Title	SITEALERT 3 (c) W.Brown VK3BYD	
Size: A3	Number	Revision: Drawing 3v1d H/W >3v7
Date: 10-Mar-2006		Sheet of
File: C:\Programs\..\sitealert3.Sch		Drawn By: W.Brown

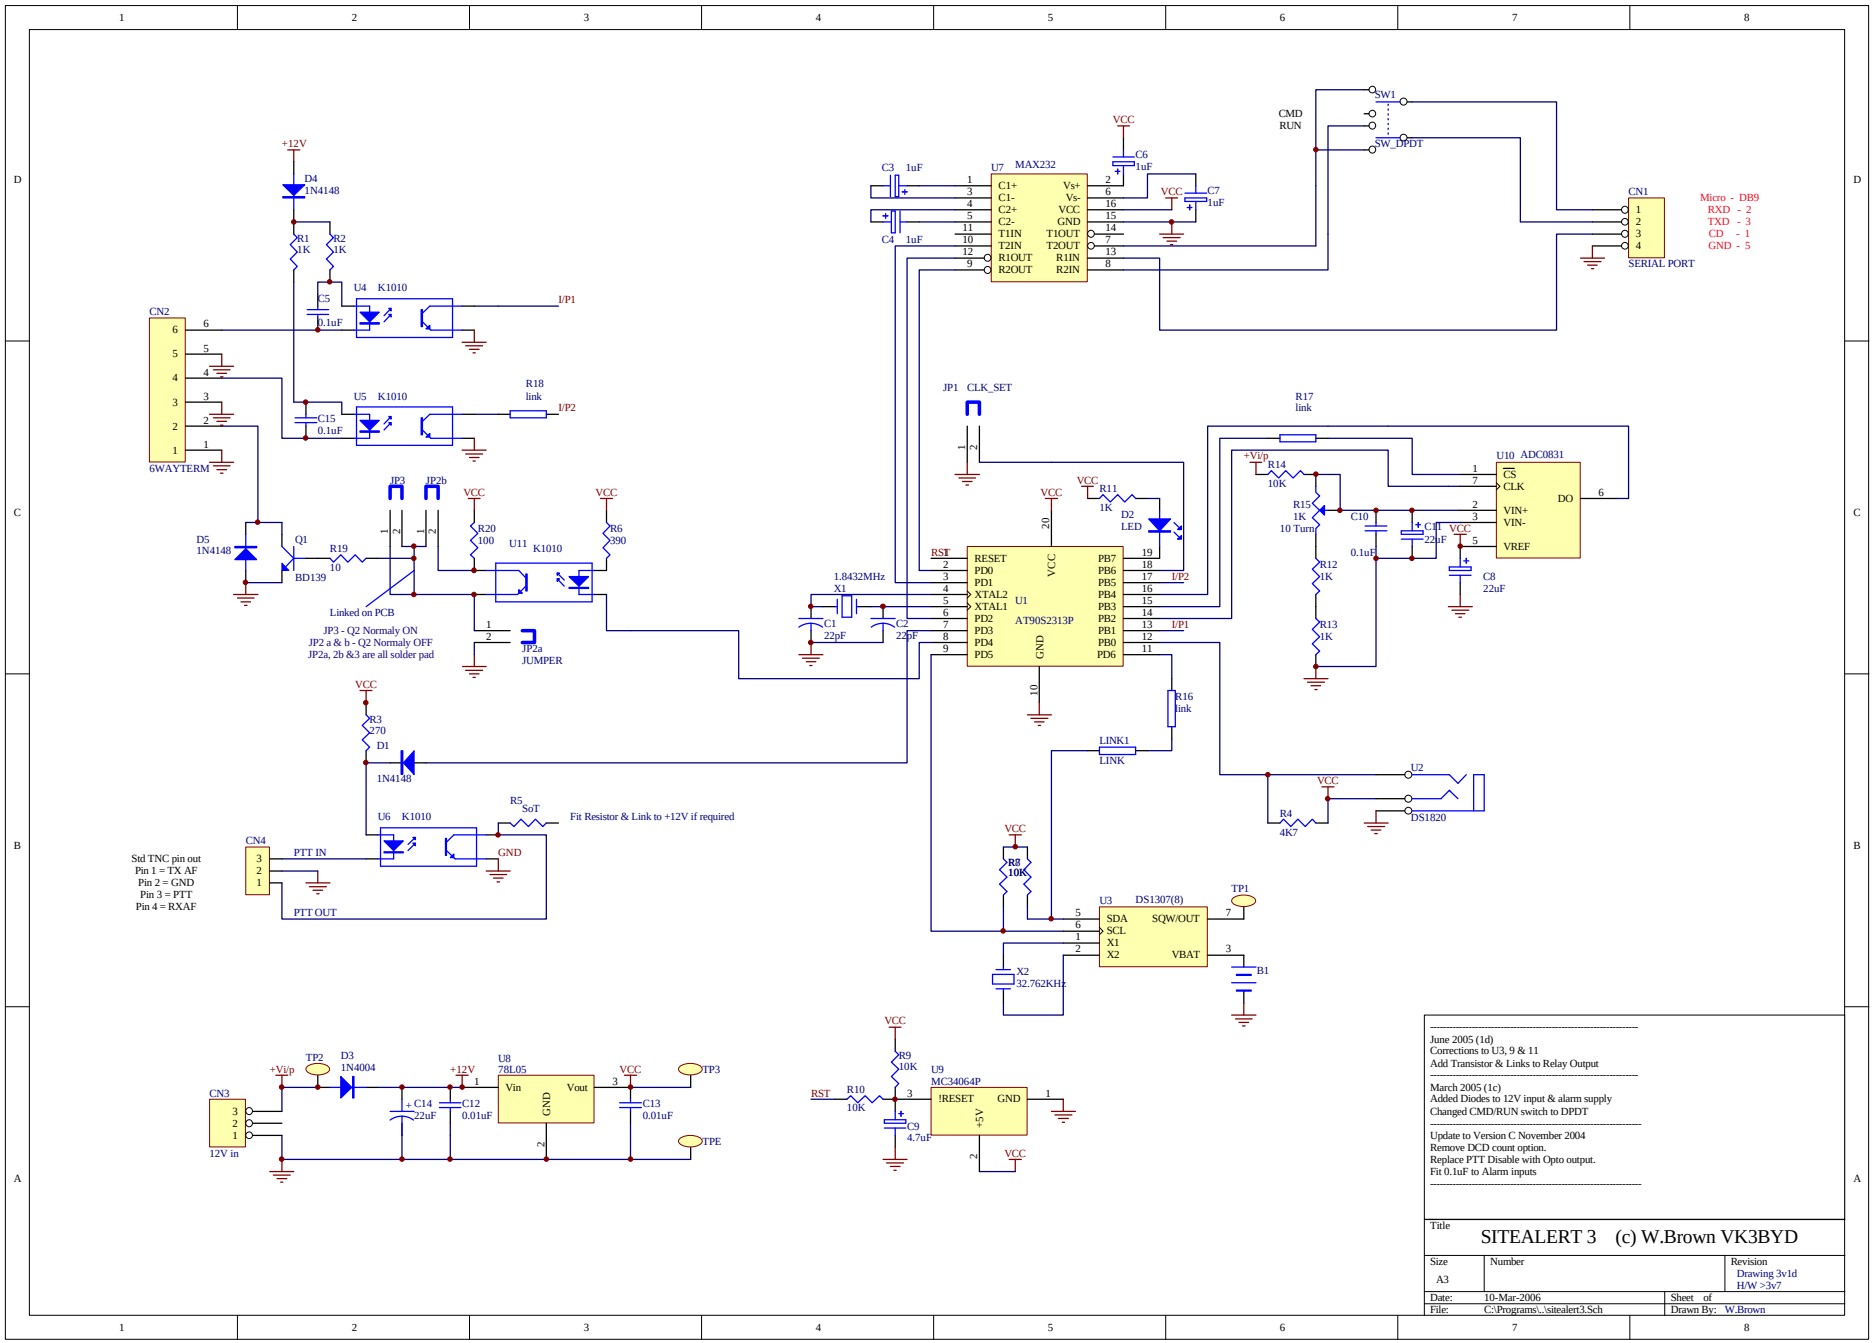
June 2005 (1d)
Corrections to U3, 9 & 11
Add Transistor & Links to Relay Output

March 2005 (1c)
Added Diodes to 12V input & alarm supply
Changed CMD/RUN switch to DPDT

Update to Version C November 2004
Remove DCD count option.
Replace PTT Disable with Opto output.
Fit 0.1uF to Alarm inputs
